RE: Comments on Notice of Preparation (NOP) of Draft Environmental Impact Report for proposed Recommissioning of State Lands Lease PRC 421 (SCH #2005061013)

**Notice of Preparation of a Draft Environmental Impact Report
For the State Lease PRC 421 Recommissioning Project
SCH #2005061013**

Recommissioning of Oil Production on Oil and Gas Lease PRC 421, Shoreline Piers

RE: PRC-421 Recommissioning Project: Notice of Preparation

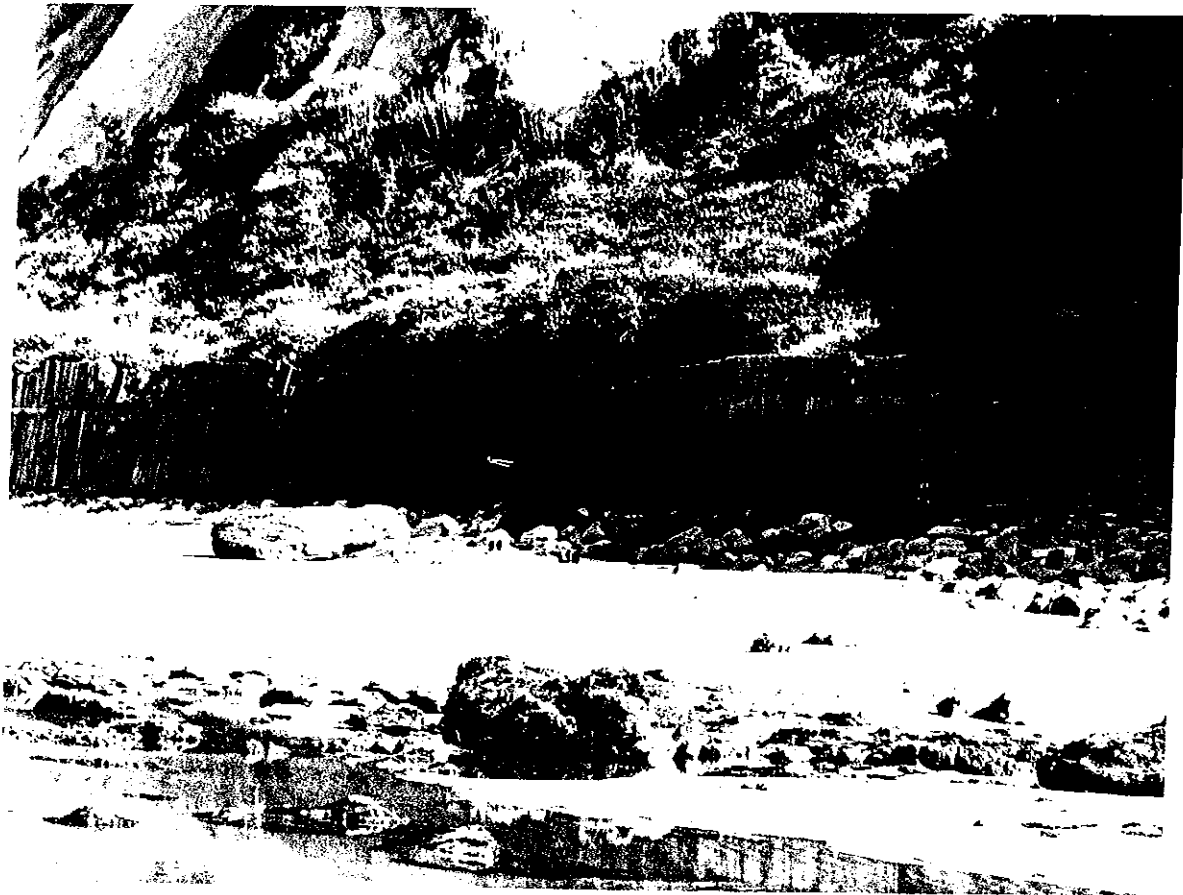
There are several questions and concerns regarding the overall condition and safety of the two piers and the causeways that connect them to the road at the base of the cliff. The causeways were repaired in 2001. New white soldier piers and I-beams were added, but a lot of the old pipe piles were retained as structural members. It is not clear what they are still supporting, but their condition is very bad and they could collapse at any time, bringing down other parts of the structure. There are the obvious safety concerns for both the workers and the public, and concerns for the impacts of any further repairs that may be required if the wells are recommissioned.

The condition of the piers or caissons has led to the emergency repair done to PRC 421-1 in 2004 and to the proposed repairs in the application to PRC 421-2. It is clearly stated on page 6 of the NOP that “the concrete coffer dam wall of the caisson has been permanently repaired etc.” but only one side of a new wall was built. The application for the repairs to 421-2 call for all four sides to be built which includes 40 steel piles going around the pier. Only 15 steel piles were placed in front of 421-1. On page 7 of the NOP it states that “The 421-2 caisson will undergo repairs comparable to those already completed at Pier 421-1”. To me, the difference between 15 and 40 is NOT comparable. Impacts resulting from the construction of the new wall around 421-2 should be determined by looking at all the problems encountered and the time-line while repairing just the front of 421-1. Also, if the current plan does not call for completing the other three walls on 421-1, then the impacts of any further and immanent repairs should be included. Access to 421-2 will be more difficult than for pier 421-1 since they will have to go under the 421-1 causeway except at very low tides. The proposed sand ramp on the beach is very close to the buried pipelines, and during the 2004 repairs, the drivers of the equipment had to cross over those pipelines several times in order to get up enough speed to get back up the soft sand ramp. It also appears that the original concrete structure was further cracked by all the heavy equipment and work – there was an oil leak that developed in the front wall that was poorly patched with epoxy, and a smelly (hydrogen sulfide) fluid was seen pouring out of cracks in the east side wall after the repairs were completed.
